October 17, 2018
BOARD OF COUNTY COMMISSIONERS
ORANGE COUNTY, FLORIDA
IFB Y19-708-JS ADDENDUM #2

**ORANGE COUNTY CONVENTION CENTER – NORTH/SOUTH BUILDING SMOKE CONTROL SYSTEMS
UPGRADE**

**Orange County
Convention Center
NS Smoke Control
Design Phase**

E901

ROOF PENETRATION DETAIL
N.T.S

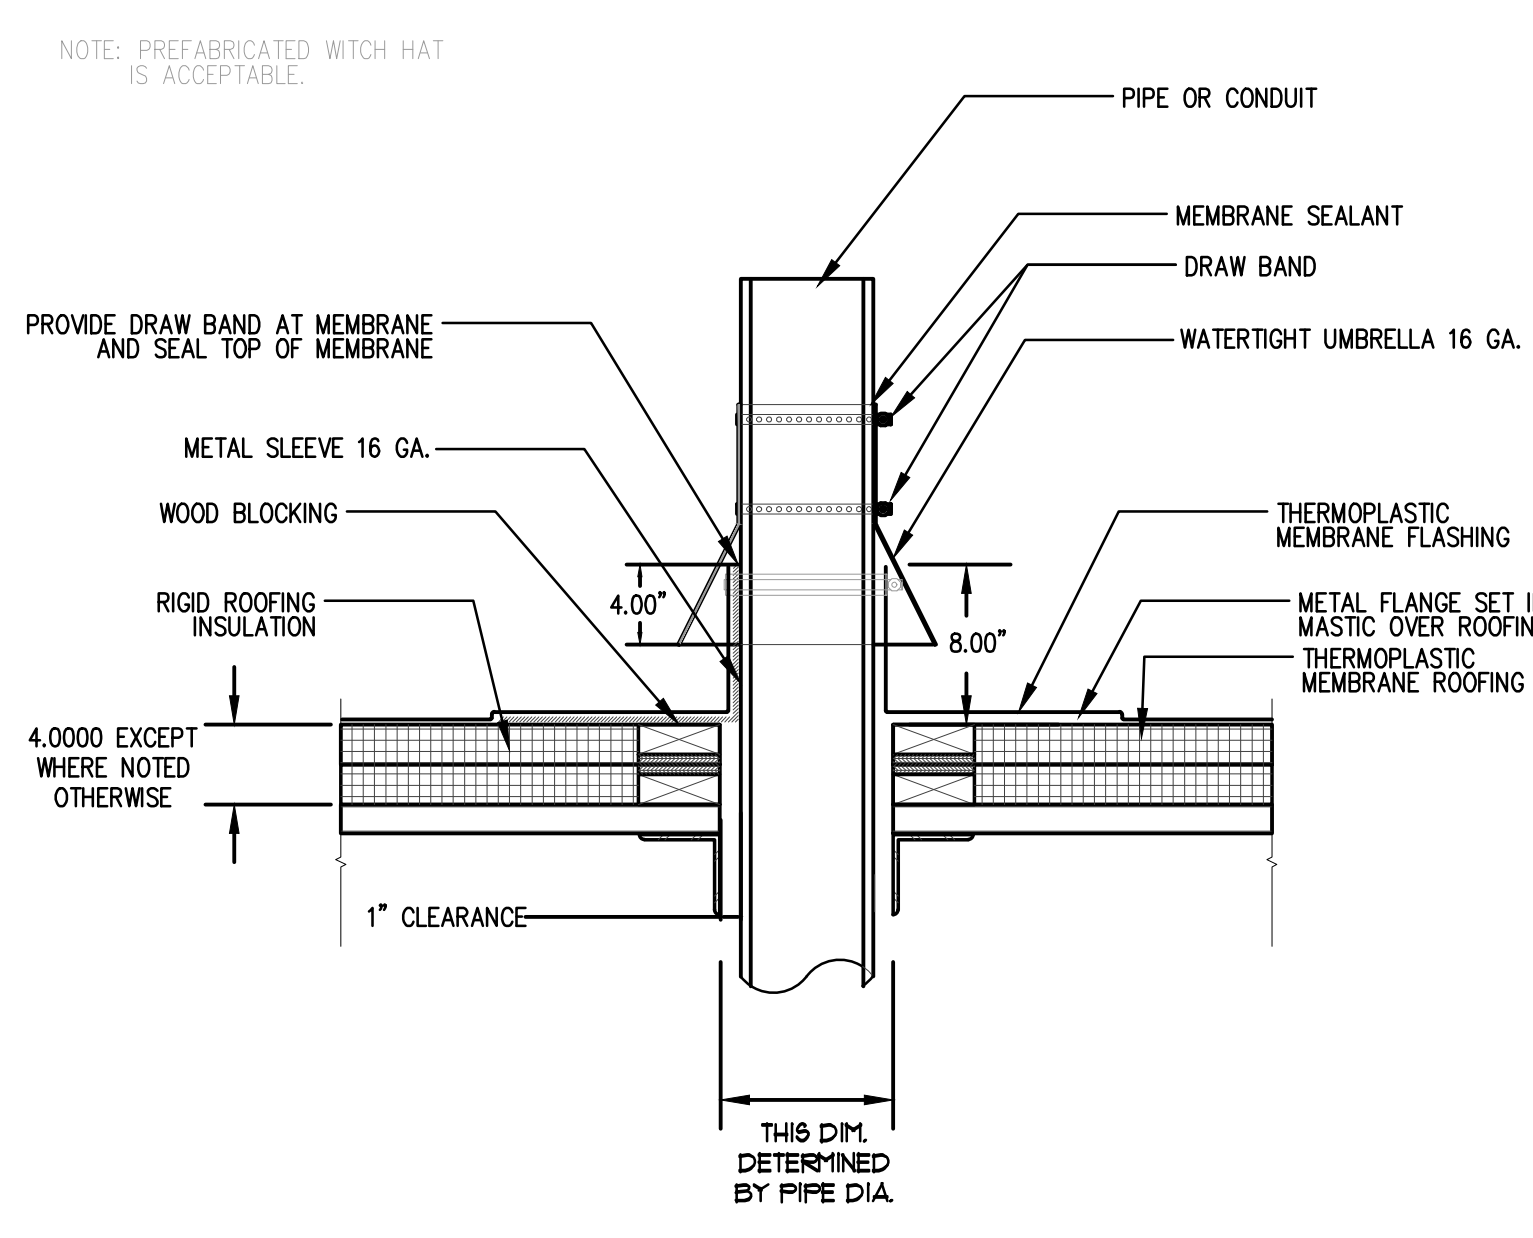
Question 5: The current requirements for RFP Y19-708 IFB do not allow for rooftop conduit runs from the FATC panels at the exhaust fans back to the inside of the building. The current RFP expectation is a roof-top penetration immediately below the unit parallel to the existing penetrations with conduit following the inside ceiling back where required. There exist 6 exhaust fans on the immediate South side of the building rooftop along with 5 exhaust fans along the immediate North side of the building rooftop. For these 11 exhaust fans, can NEC approved rooftops conduit runs using an approved rigid or a PVC coated conduit, one conduit run for each of the 11 units, be used along with a CADDY FIXED STRUT, 10" C-CHANNEL and Stainless Steel straps other approved NEC rooftop conduit securing method, and taking into consideration the ampacity for the circuit wire within, be used to take the smoke control circuit back into the side of the primary Mechanical Rooms between the two outside rooftops? Doing so would provide an overall cost savings to the project.

Response 5: The OCCC does not want conduit runs on the roof due to an upcoming roof replacement project. Please install per plans and specifications.

FIRE ALARM SMOKE EXHAUST FAN RELAY DETAIL
N.T.S

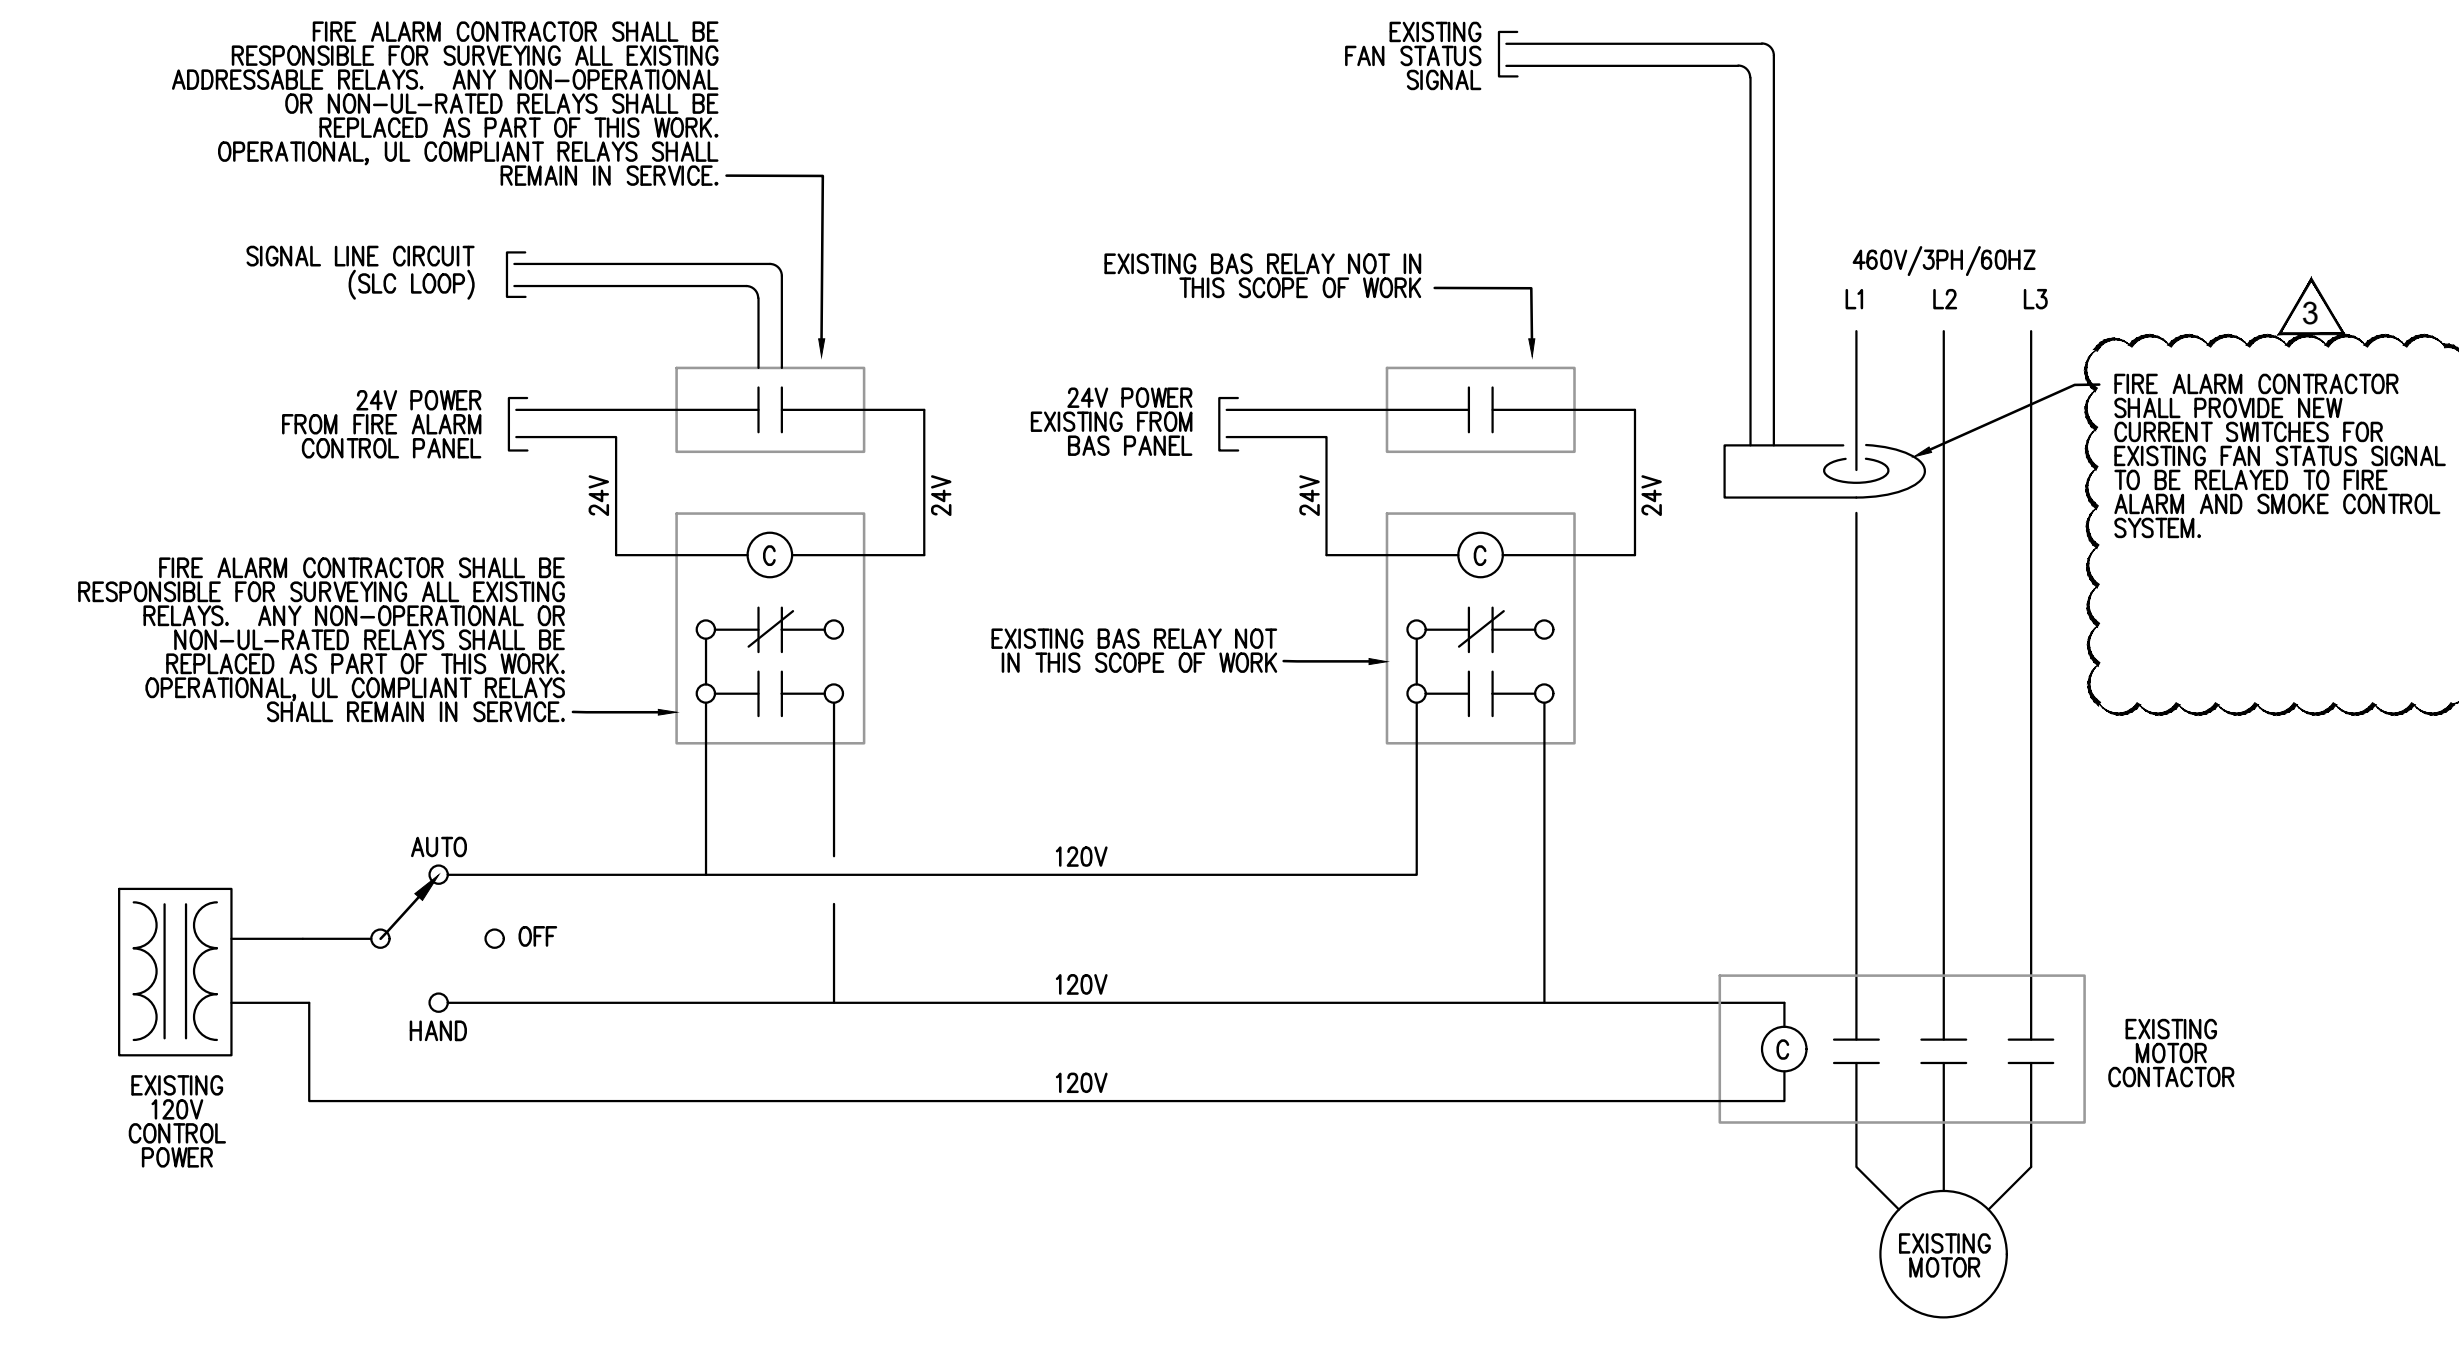
Question 3: On sheet E901, Fire Alarm Smoke Exhaust Fan Relay Detail, Note 2; directs the contractor to “Install FA relays immediately adjacent to fan/starters they serve.” If “no FATC are being added to the rooftop” Was it the designer’s intent that these FA relays go inside the Exhaust Fan starters on the rooftop?

Question 4: If the FA relays are intended to go immediately adjacent to the fan/starters on the rooftop, please confirm an FATC next to each existing starter is acceptable.

Response 3: Yes, this is anticipated

Response 4: The intent is for the FA relays to be installed inside the exhaust fan starters.
